**FINAL
MY1 MONITORING REPORT**

NESBIT SITE

Response to DMS Comments

Nesbit Stream and Wetland Mitigation Site, Union County
Catawba River Basin, Cataloging Unit 03050103
DMS Project ID No. 100121, Full Delivery Contract No. 7868, RFP No. 16-007704
USACE Action ID No. SAW-2019-00832, DWR Project No. 2019-0862

Figure 1. Current Conditions Plan View

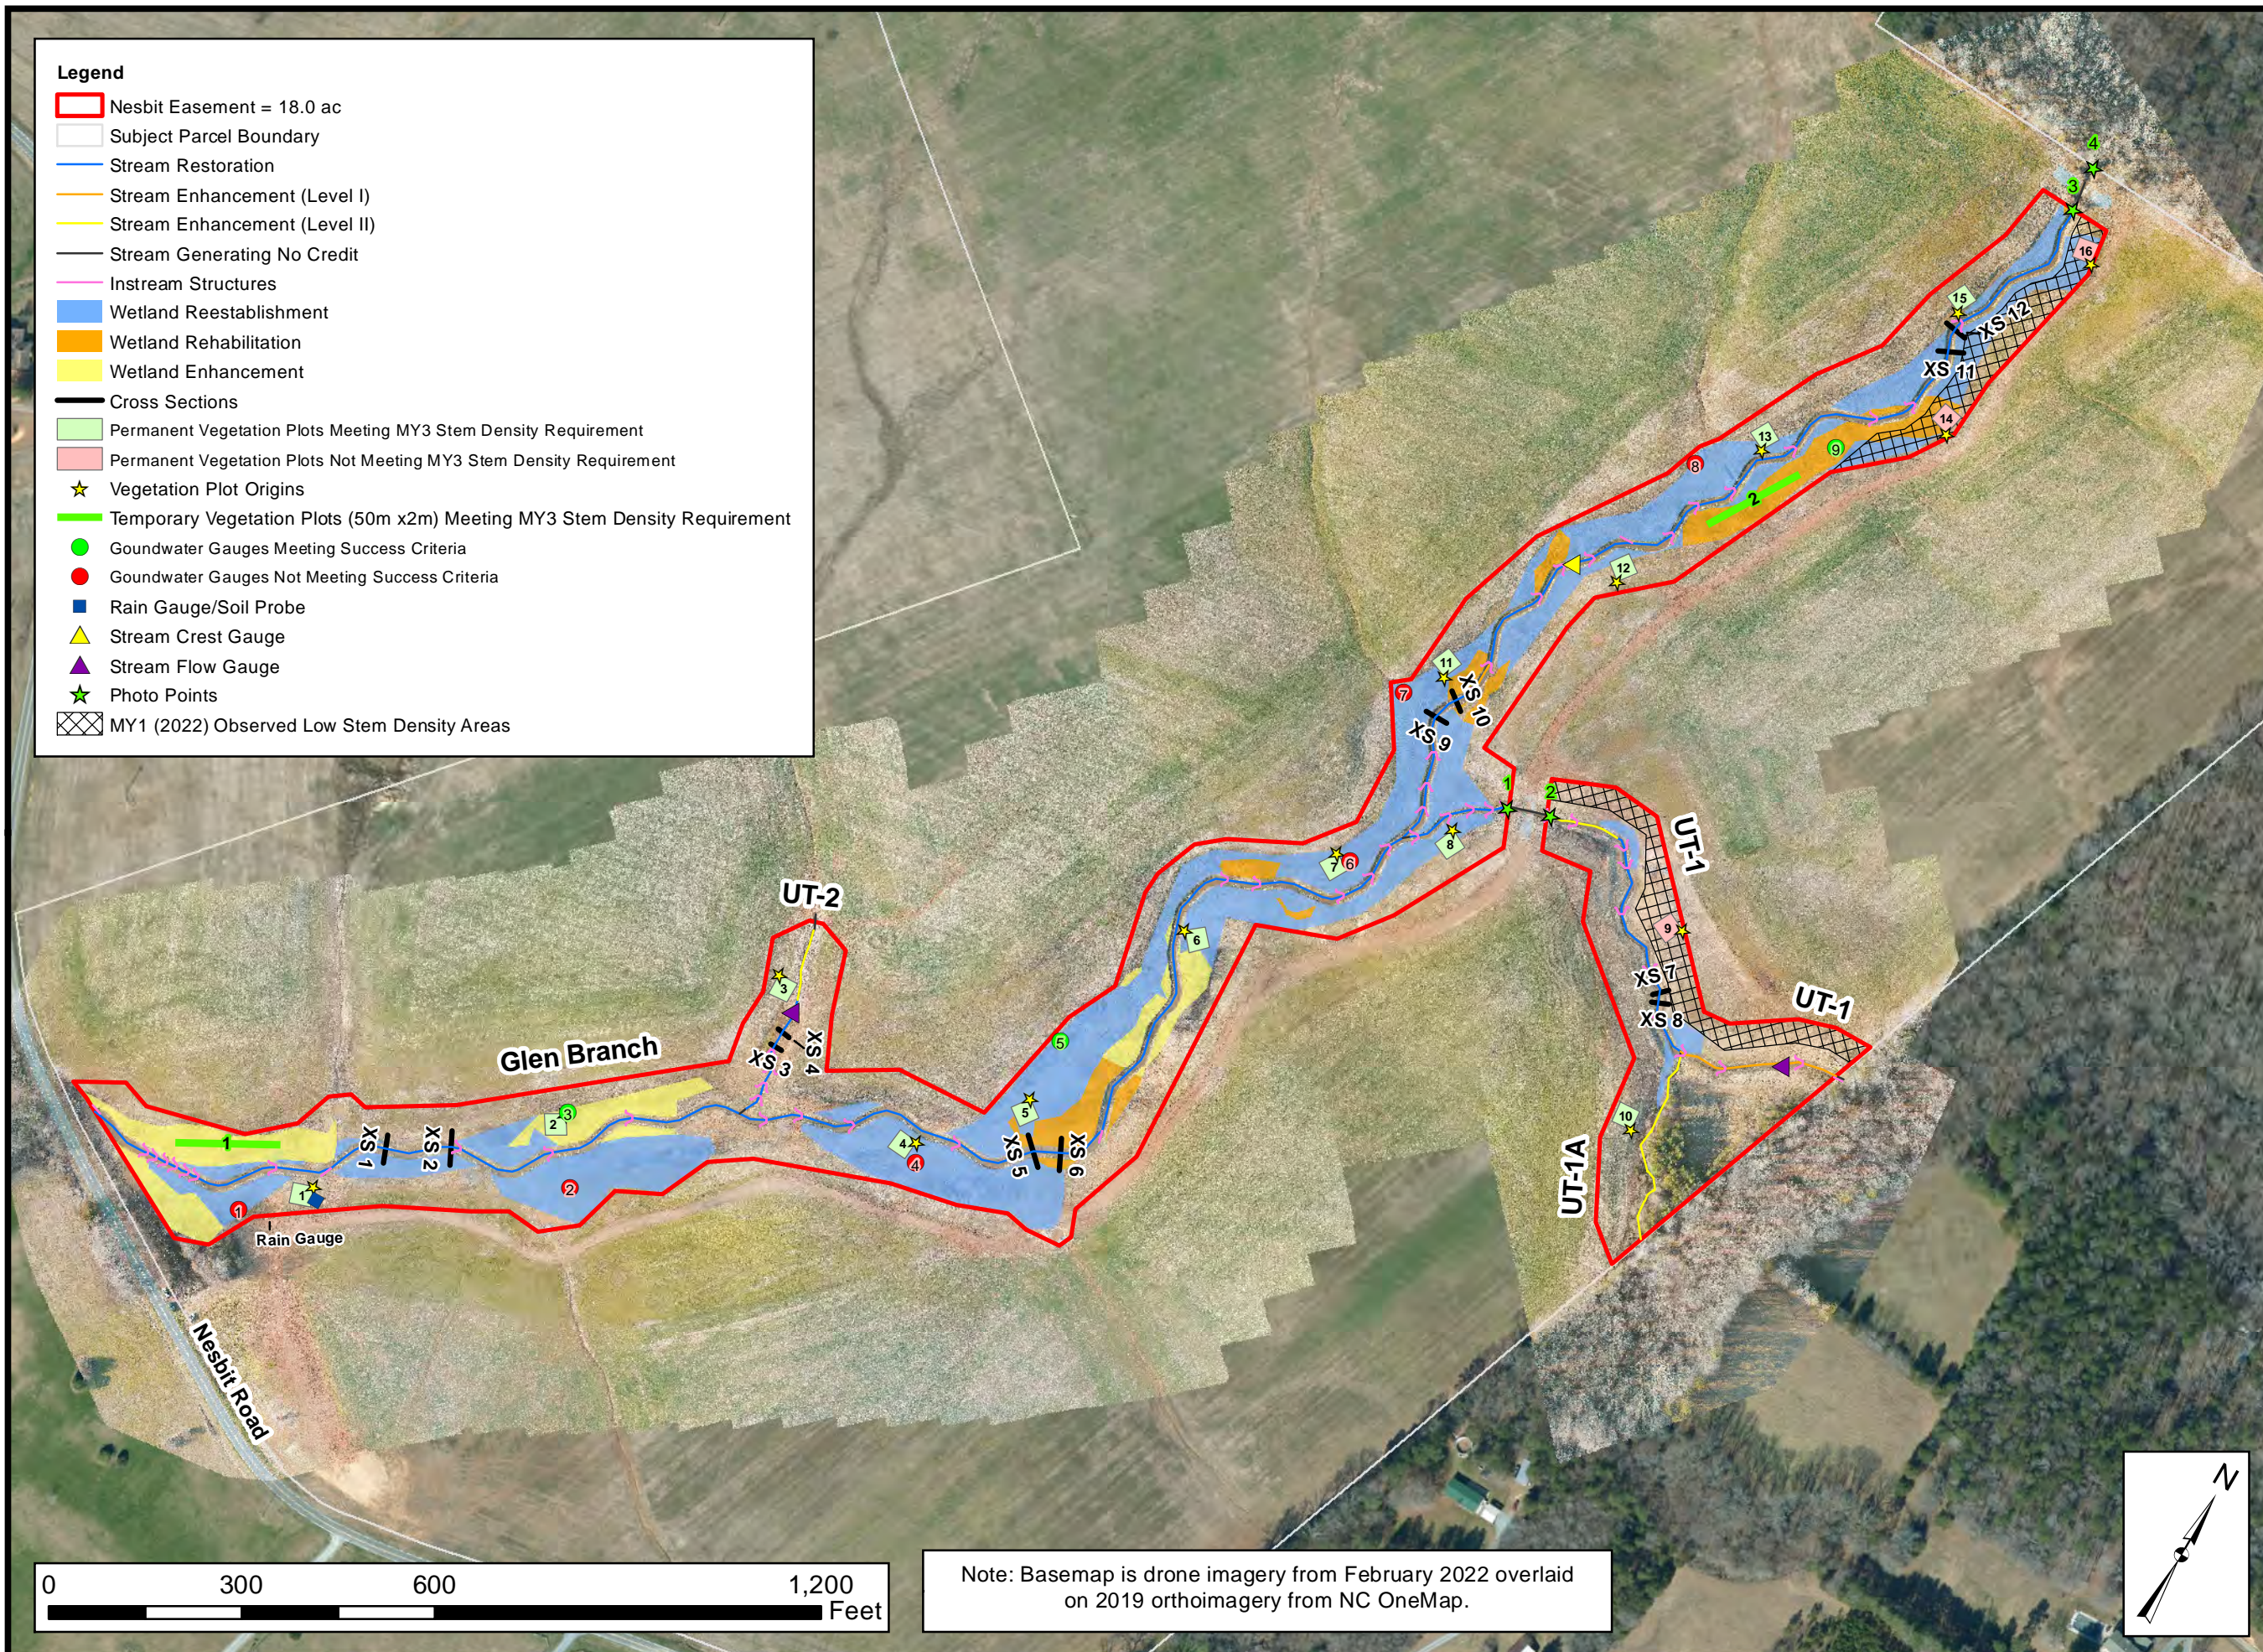
3. Figure 1 CCPV: The location for Photos 1 and 2 on Figure 1 are at the upstream and downstream end of the UT-1 crossing. Photos 1 and 2 in the photo log are a site overview and Glen Branch. Please include photos for both views at each crossing and edit the CCPV photo locations to match the Photo Log for all referenced photos.

Response: The four photo points depicted on the CCPV are the only permanent site photo points proposed (other than vegetation plot photos and cross-section photos). These photos have been moved to the front of the photo log to avoid confusion and will be photographed annually. The additional photos in the photo log are to provide a general overview of site conditions, and their locations will change from year to year. Therefore, a description of each photo location is provided, but they will not be depicted as permanent photo points on the CCPV.
